A brief description of the refinements is provided on pages 2 and 3 of this MPR request and a list of refinements and the reason for each is provided in Attachment A: Refinement Table and Project Impacts Table.

Table 1: Project Refinement Table lists each refinement alphabetically by Transmission Line (TL) 625B and TL629E as part of the San Diego Gas & Electric Company (SDG&E) Cleveland National Forest Power Line Replacement Projects (Project). The refinements are a result of the Project's final design and a brief explanation of the need for each refinement is included. This table also includes the temporary and permanent impacts associated with the requested refinements by type and alignment.

**Cleveland National Forest
Power Line Replacement Projects**

**Attachment D:
Compare Map
TL629E Map 46 of 46**

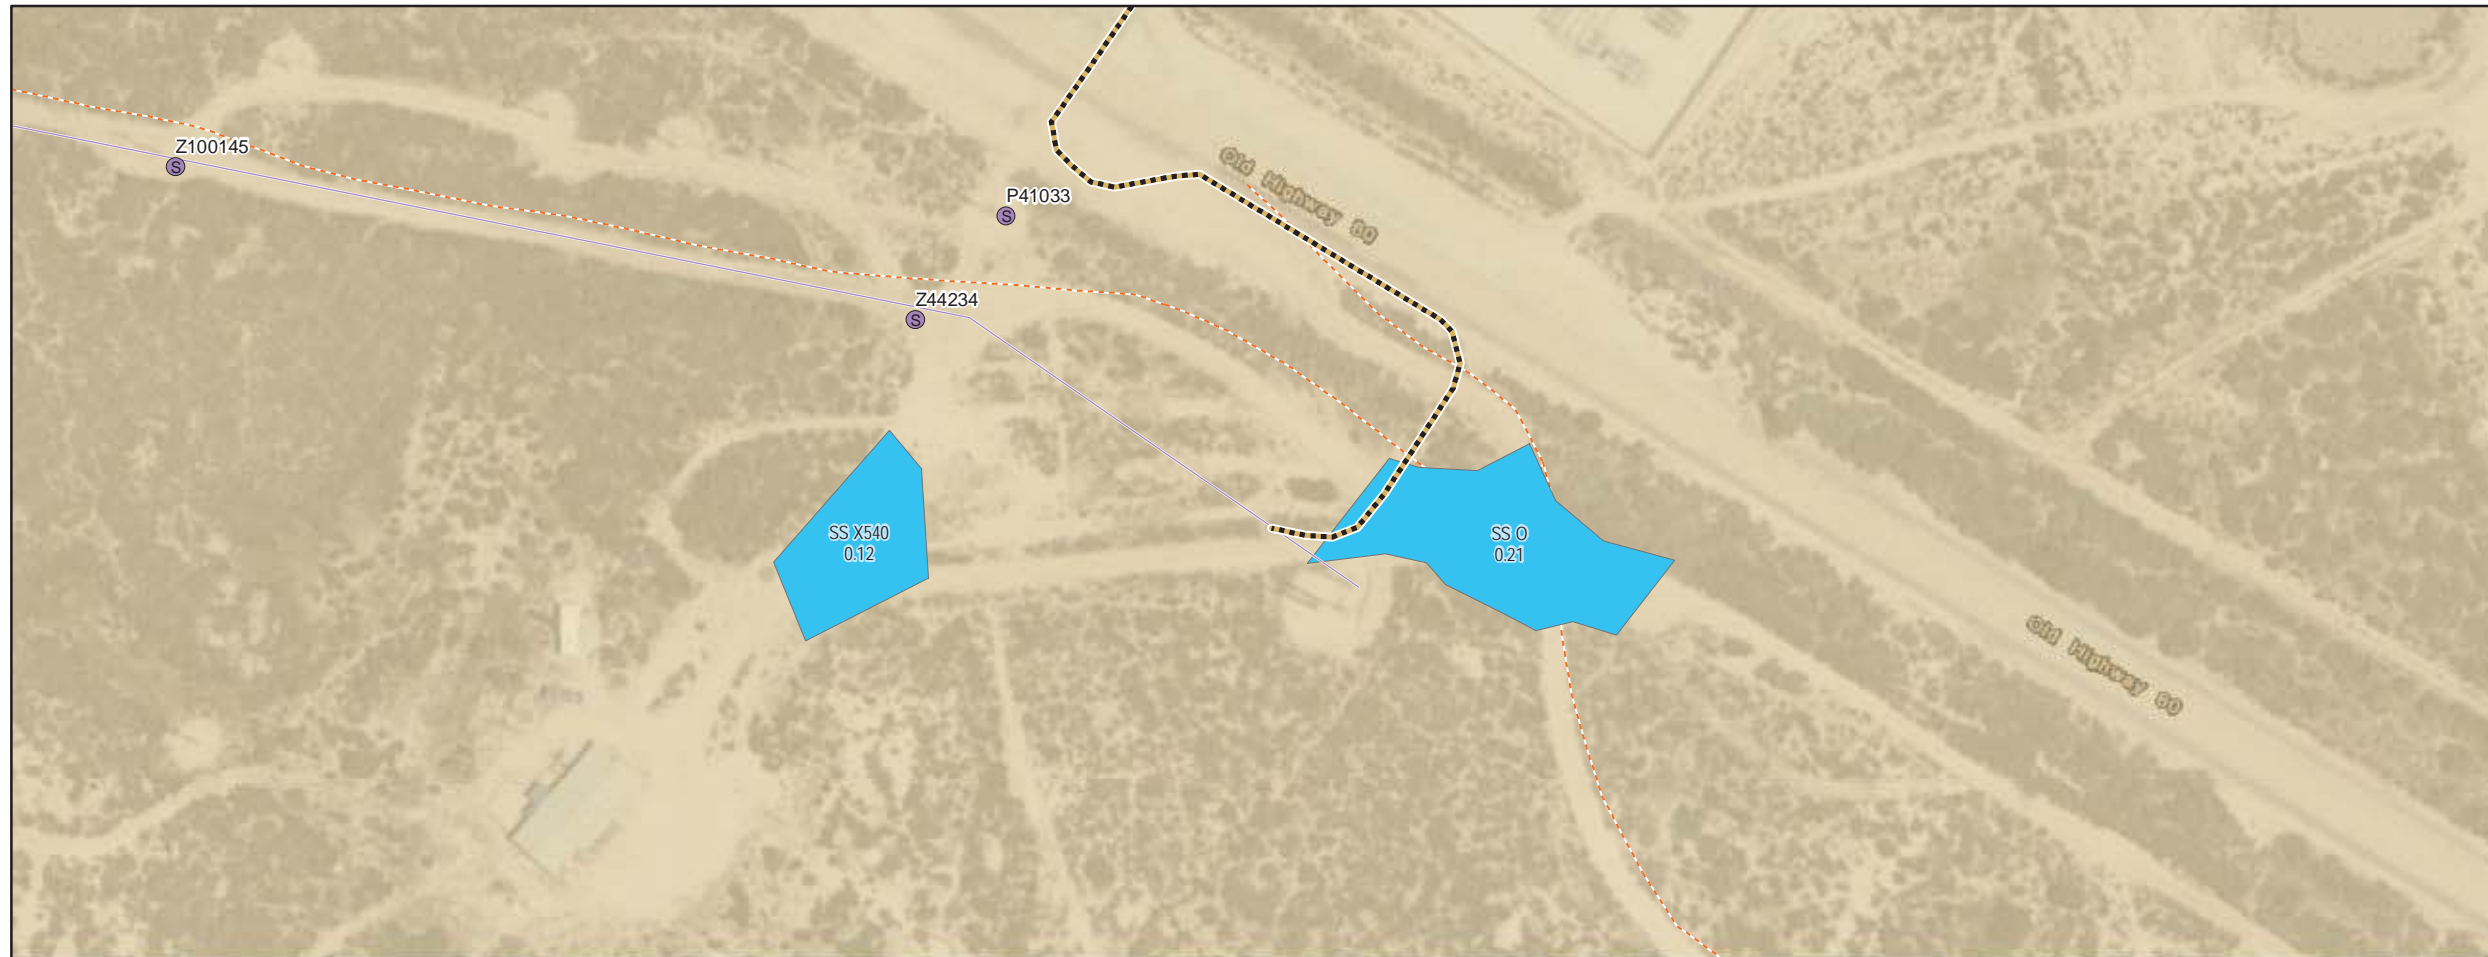
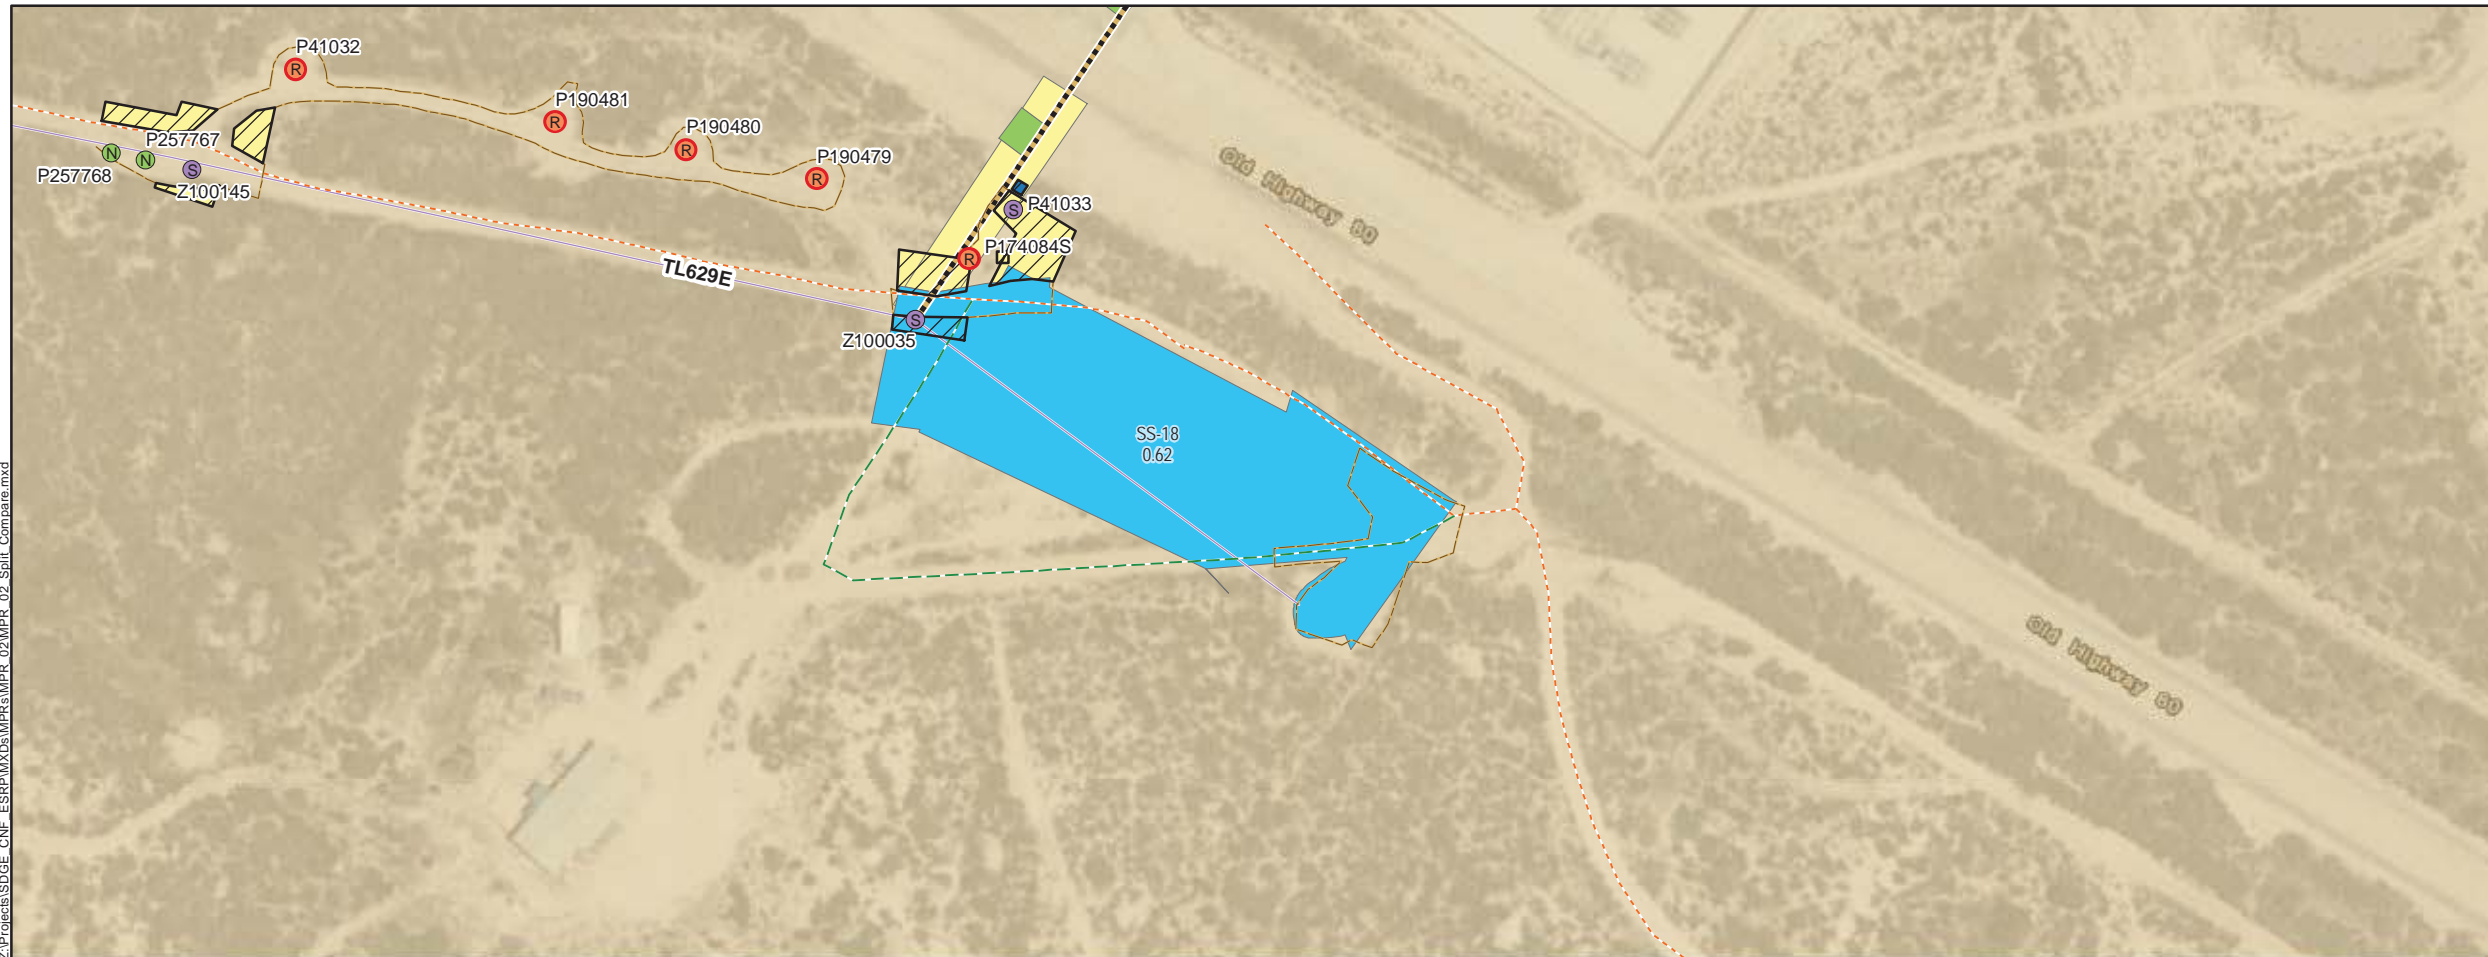
SS-18	45 & 46 of 46	Reconfiguration of the approved stringing site dimensions and size from approximately 0.21 acre to 0.62 acre	The stringing site was reconfigured to better align with the final engineering of terminal dead ends and provide more adequate pulling tensions. Additionally, the realignment and reconfiguration of the stringing sites better aligns with the transmission line, which reduces pulling tensions and helps prevent potential stringing operations complications and conductor damage.
Temporary Impacts: 1.06 acres (0.32 acre of disturbed/developed areas, 0.23 acre of non-native grassland, 0.51 acre native vegetation)			
Permanent Impacts: 0.00 acres			
TW-29	1 of 46	Addition of a new temporary workspace	The temporary workspace is being added to conduct pole top work at Pole P192945.
TW-30	1 of 46	Addition of a new temporary workspace	The temporary workspace is being added to accommodate equipment and vehicle turnaround to Pole Z40572.

TWE-14	45 of 46	Addition of a new temporary work entry area	The temporary work entry area is being added to minimize potential traffic flow impacts into the Golden Acorn Casino during undergrounding activities at the Crestwood Substation.
Temporary Impacts: 0.66 acres (0.34 acre of disturbed/developed areas, 0.30 acre of native vegetation, and 0.02 acre of pastureland/agriculture)			
Permanent Impacts: 0.00 acres			
Undergrounding-01	45 of 46	Realignment of underground trench	The underground trench was realigned to facilitate undergrounding distribution cable to the Crestwood Substation.
Temporary Impacts: 0.00 acres⁶			
Permanent Impacts: 0.00 acres			
Vault-01	4 of 46	Addition of a new temporary vault workspace	The temporary vault workspace is being added to accommodate equipment and replace underground distribution cable.
Temporary Impacts: 0.02 acres (0.02 acre of native vegetation)			
Permanent Impacts: 0.00 acres
